# ENDL TEXAS

Date: 23 August 2006  
 To: T10 Technical Committee  
 From: Ralph O. Weber  
 Subject: Security Association Model for SPC-4

**Figure x1 — SA relationships**

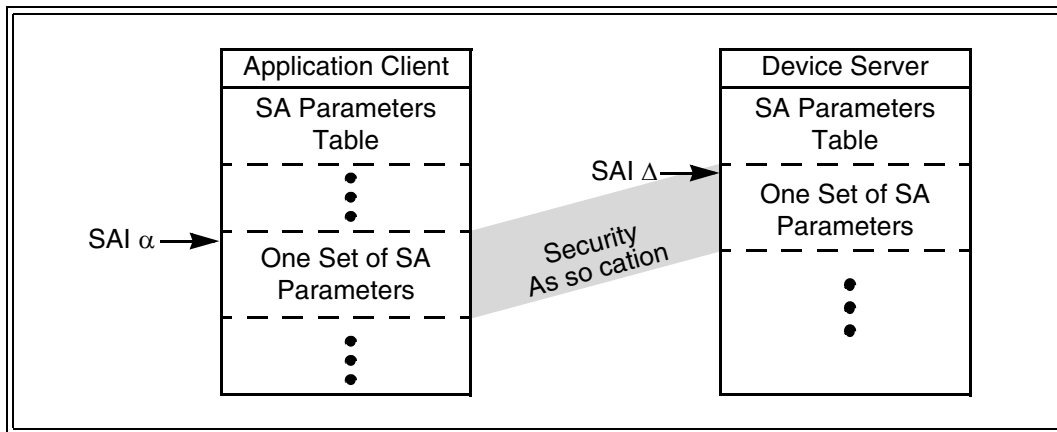
Figure x1 shows the relationship between application clients and device servers with respect to SAs.

In both the application client and the device server, the SA parameters are modelled as being stored in an indexed array and the SAI identifies one set of SA parameters within that array. The application client and device server are not required to store the parameters for any given SA in the same array locations. In order to support this implementation flexibility, a single SA is modelled as having two different SAI values (i.e., one for the application client and one for the device server).
